CITY PLANNING COMMISSION

- APPLICATION:
1. Negative Declaration
 2. Amendment of the Delta Point PUD Schematic Plan from 190 units to 320 units
 3. Rezone from Townhouse R-1A (PUD) to Garden Apartment R-2A (PUD)
 4. Special Permit to develop 320 condominium units
 5. Tentative Map

APPLC. NO. P82-151

SHEET NO. 1 OF 3
 PROJECT TITLE Delta Point West Condominiums
 Pacific Coast of Sacramento, Inc.

Schematic site plan

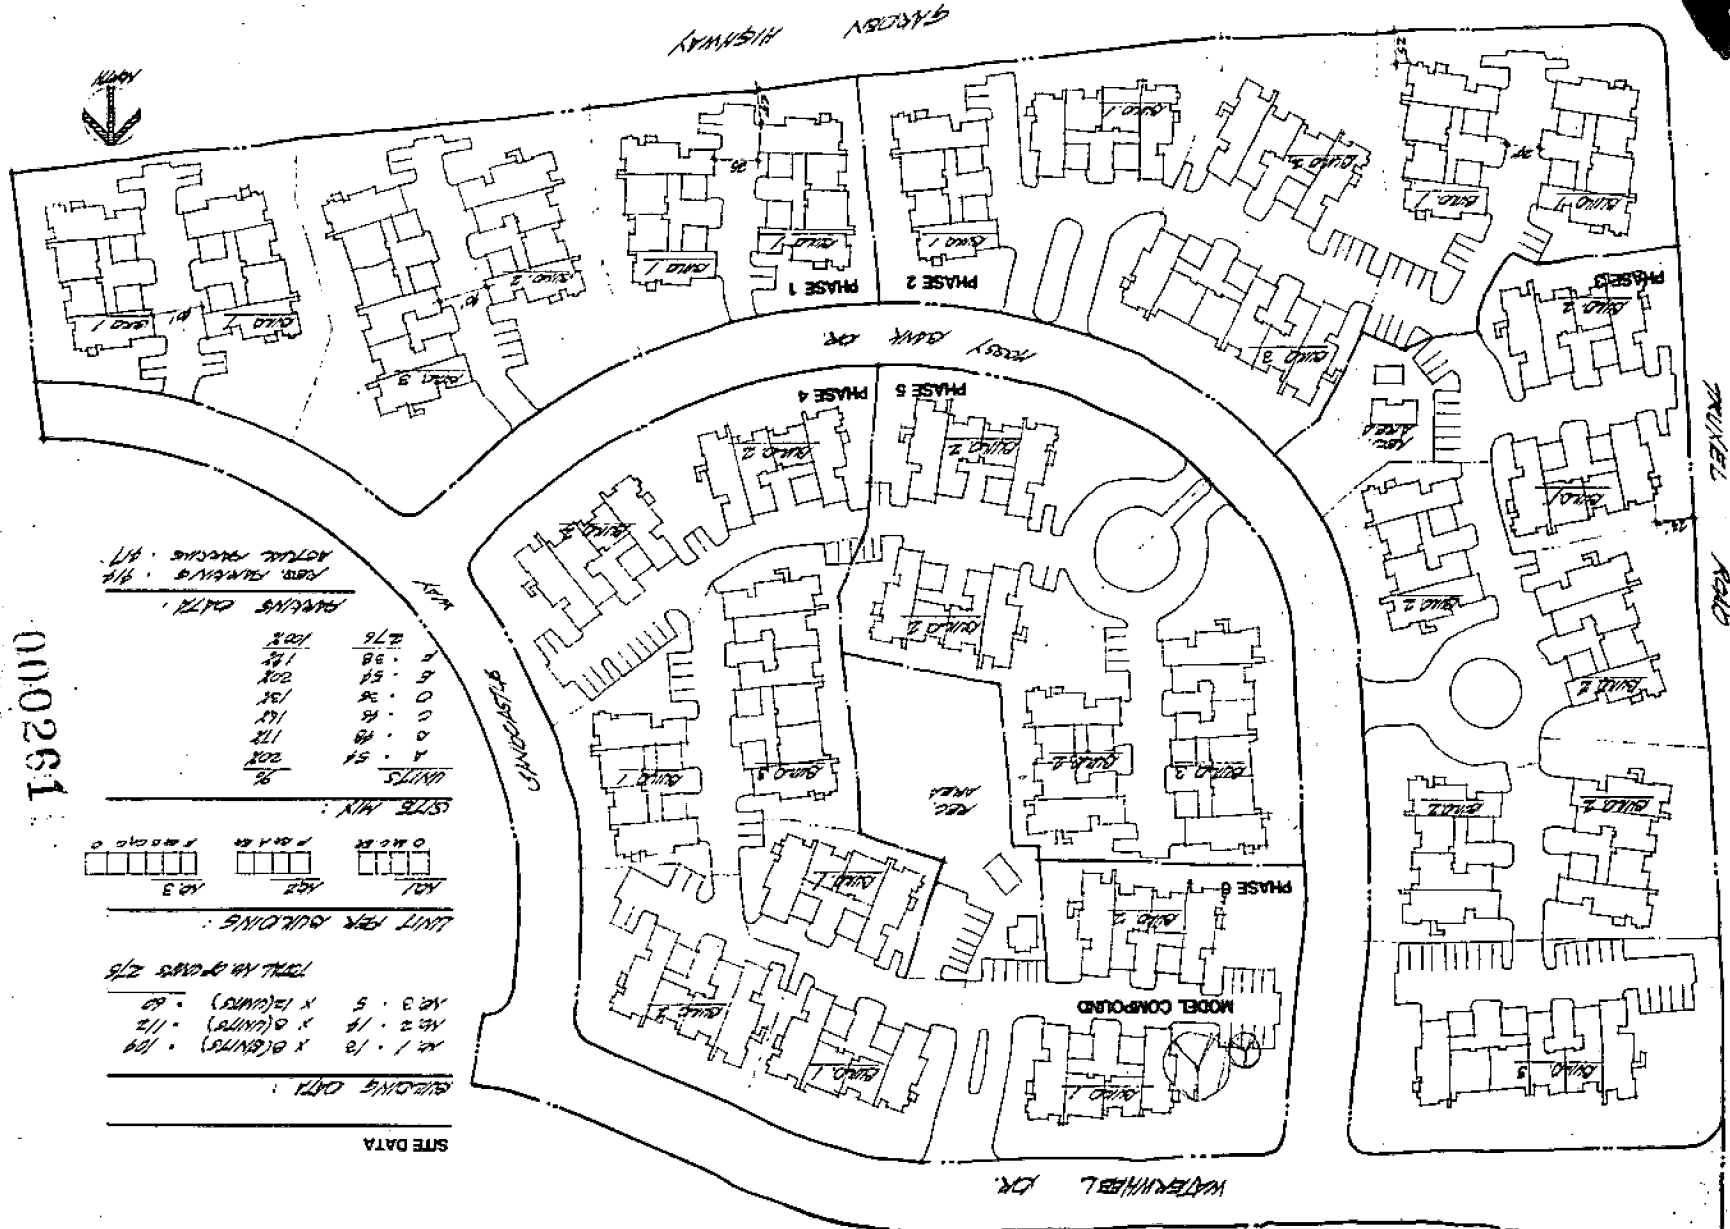
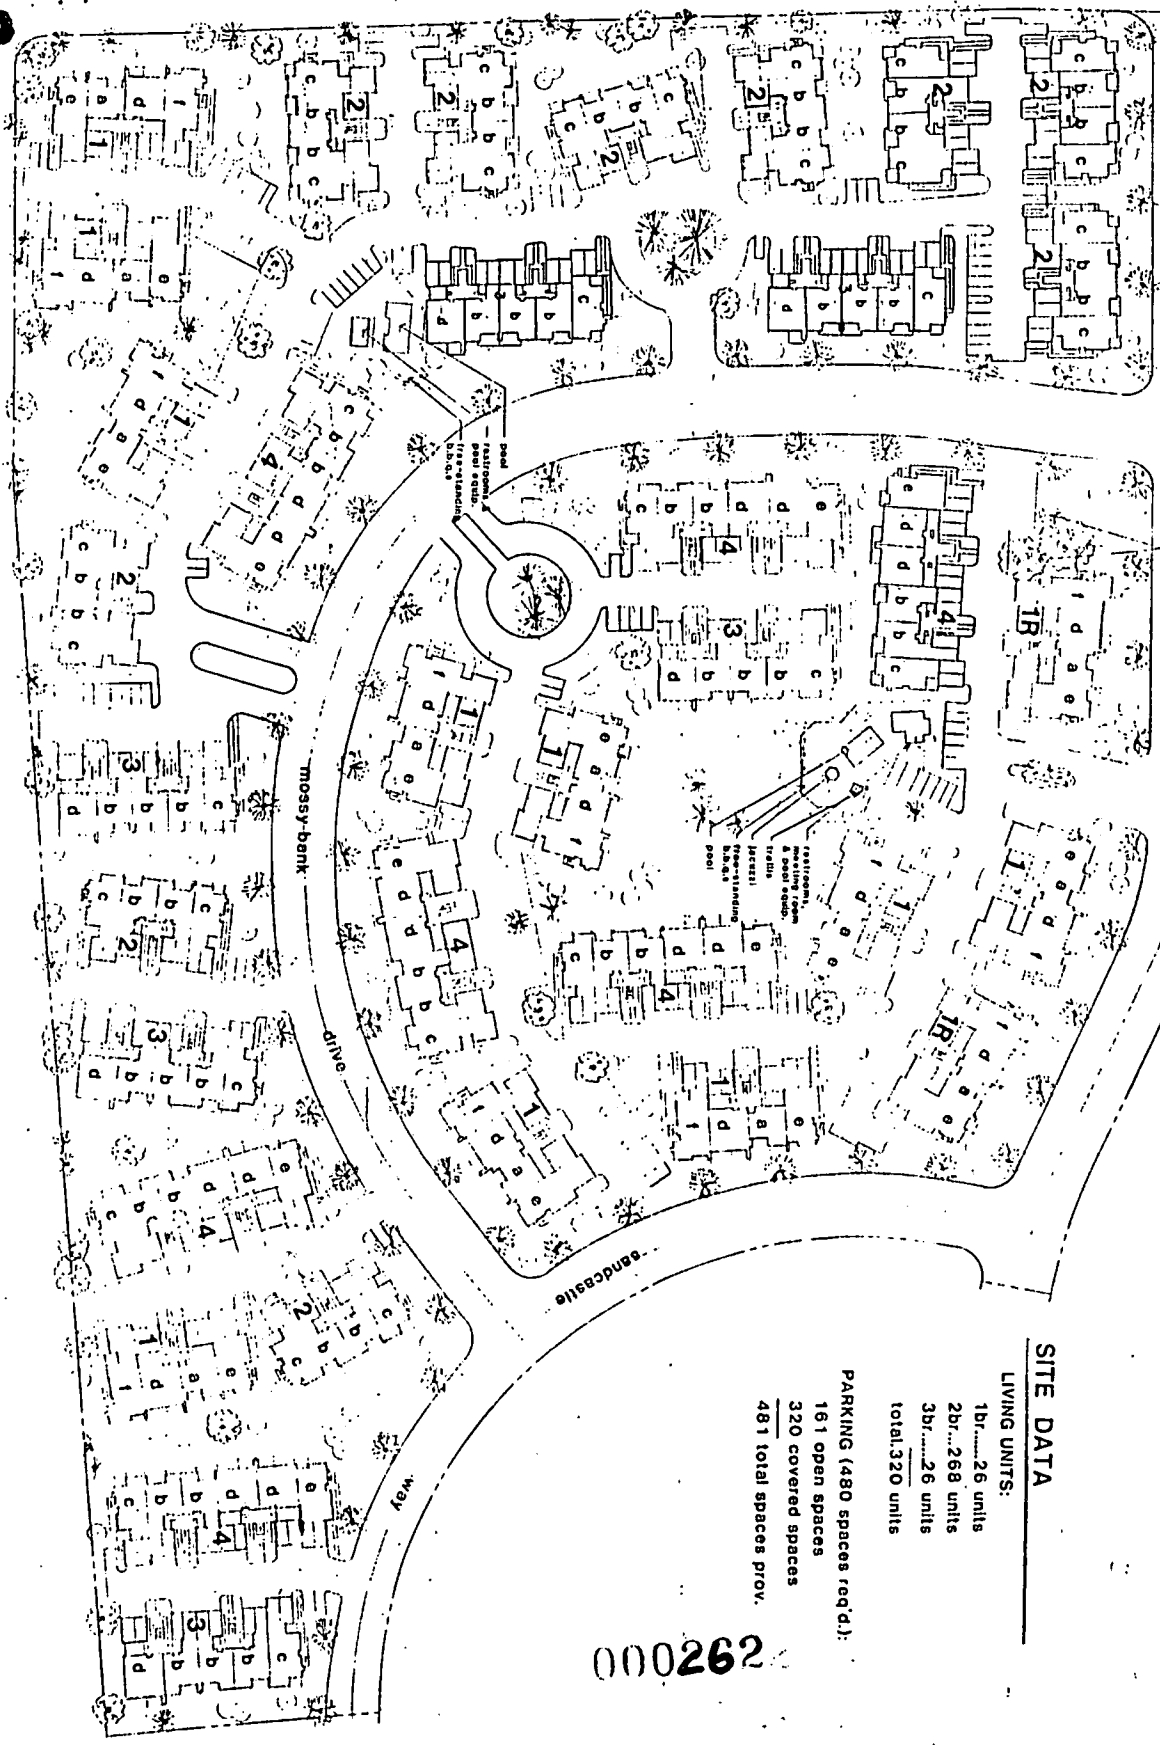
3. The requested Garden Apartments R-2A zone permits a maximum density of 17 units per acre which is consistent with the applicant's proposal. The R-2A zone also requires a minimum 25-foot setback along all public streets. The site plan will have to be revised to incorporate this setback throughout the development.

5. The proposed project achieves only a 70 percent north/south unit orientation. Staff finds that it is infeasible to redesign the project to attain the 80 percent north/south lot/structure orientation due to the public street pattern and lot configuration. When the original project for the subject property was approved in 1980 (same street pattern) a total of 50 percent north/south orientation was required.

6. The site plan indicates a large amount of landscaped areas throughout the site. To ensure these areas are adequately landscaped and developed in accordance with the Delta Point PUD Guidelines, staff requests that the applicant adhere to the multiple family design criteria (Exhibit A).
7. The project was transmitted to the South Natomas Advisory Committee for review and comment. No comments were received at the writing of this report.

To compensate for the low percentage of north/south orientation, staff recommends that as a condition of the special permit, the applicant submit detailed plans which incorporate passive and active solar design considerations for the review and approval of the staff prior to the issuance of building permits.

- b. The site plan shall be revised to incorporate a 25-foot setback for structures and fences adjacent to all public streets;
- c. Prior to issuance of building permits, the applicant shall submit detailed plans which incorporate passive or active solar design consideration for the review and approval of the staff. Such design considerations may include eave overhangs, added insulation, south wall solar glazing, etc.;
